Architectural Review and Historic Preservation Board Agenda Report

Files: AR 21-02

RE: AR 21-02 (NVADG) – APN 047-560-076 & 047-560-125, 1.26-acre site located
south of Lockheed Avenue, between Marauder Street and Fortress Street

SITE PLAN
SCALE: 1" = 20'-0"

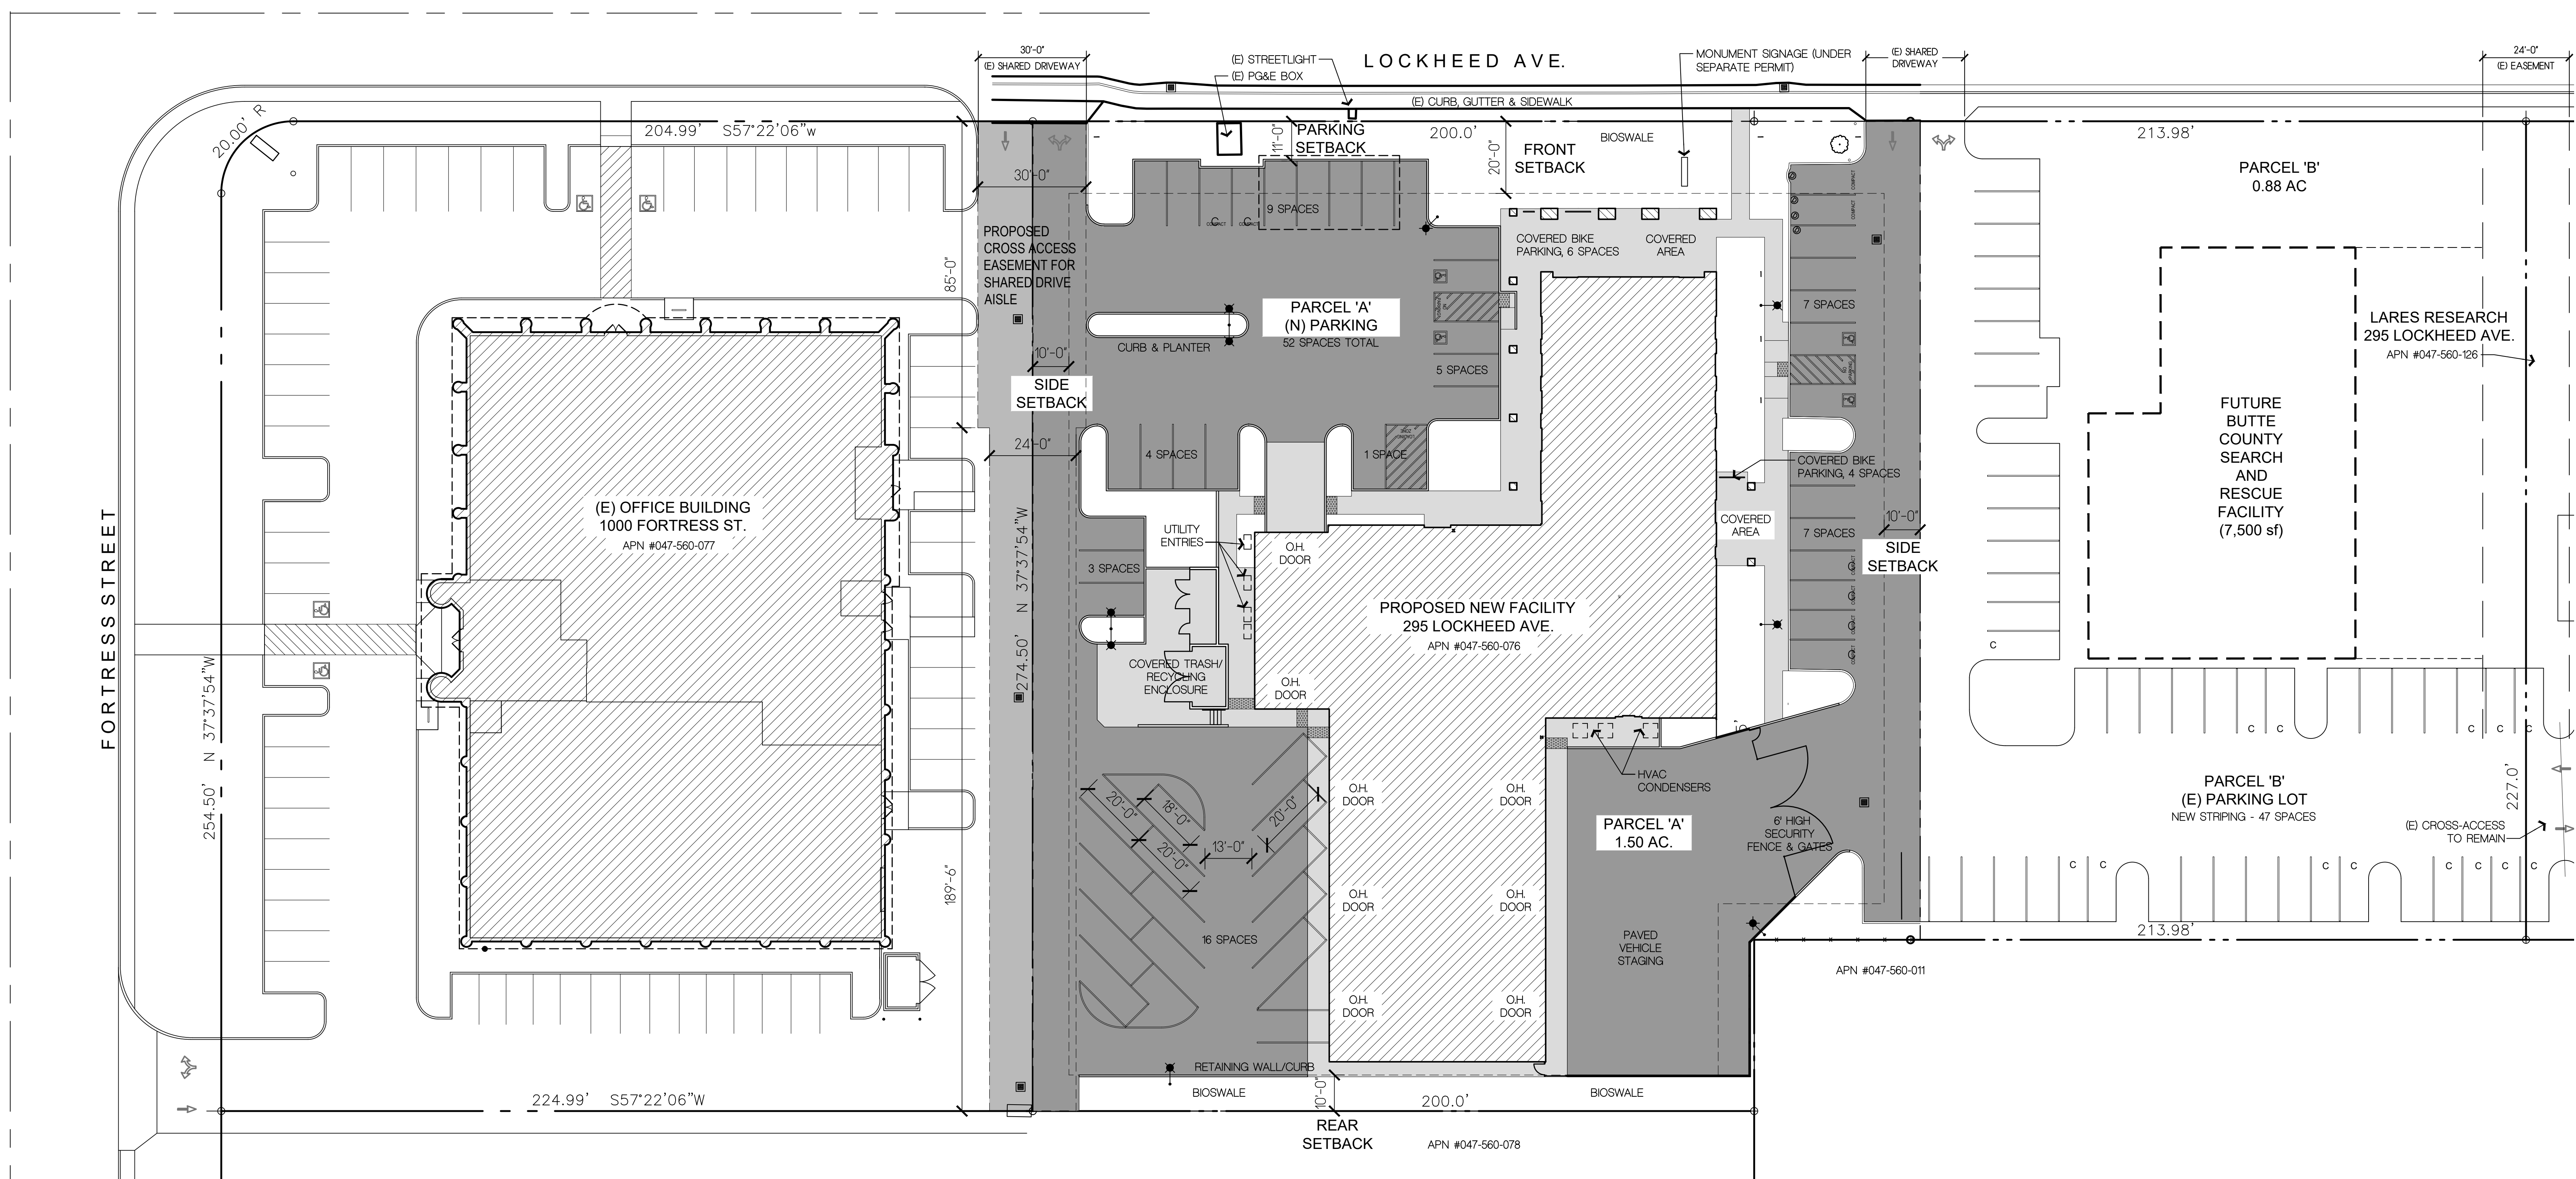
Access to the site will be taken from Lockheed Avenue with driveway ingress and egress being shared with properties to the east and west (**see recommended Condition #2**). The proposed building would be situated with the primary public entrances facing toward the northeast parking lot. (**Attachment B**, over all site plan). There will be a covered “breakout” space that faces Lockheed Avenue that will be used during trainings and will also serve as an entrance to the training room. The two warehouse spaces that will be used to store “dry” supplies and house the command center and specialized vehicles will be situated on the southernly portion of the project site.

Parking will be located to both the east and west of the building. The primary use of this space will be office space and warehouse use. Volunteer trainings happen periodically throughout the year and generally take place in the evening outside of normal working business hours. Ample parking is provided throughout the site and off-site parking is included to ensure there is adequate parking during training exercises. The adjacent property to the east is owned by NVADG and will be utilized for excess parking when needed. Bicycle parking is proposed resulting in a total of 10 covered spaces located at the front entrance under the covered exterior area of the building.

1. All approved building plans and permits shall note on the cover sheet that the project shall comply with AR 21-02 (NVADG).
2. Prior to the issuance of a certificate of occupancy, applicant shall secure cross access easements with adjacent properties for shared parking.
3. All wall-mounted utilities and roof or wall penetrations, including vent stacks, utility boxes, exhaust vents, gas meters and similar equipment, shall be screened by appropriate materials and colors. Adequate screening shall be verified by Planning staff prior to issuance of a certificate of occupancy.
4. Replace crape myrtle trees with a different ornamental tree species of similar size.
